APPLICATION NO.	FILING DATE	FIRST NAMED INVENTOR	ATTORNEY DOCKET NO.	CONFIRMATION NO.
10/086,908	02/28/2002	Will G. Fetherolf	10015361-1	1658

Office Action Summary

DETAILED ACTION

FIG. 2

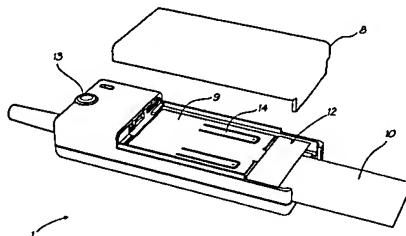
- {claims 6 and 16} print media processing engine (figure 2, reference 12) where the depth is smaller than the height and the width (figure 2, reference 12)

FIG. 3

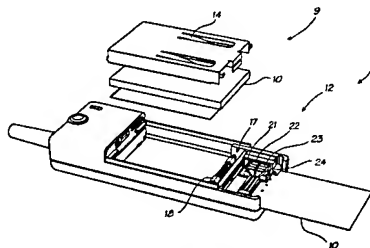
- {claims 11 and 18} media receiver orders a plurality of media (figure 3, reference 9)

received from the media output by gravity force (figure 4, reference 10, 17; inherent because media exits in downward direction and gravity has downward pull)
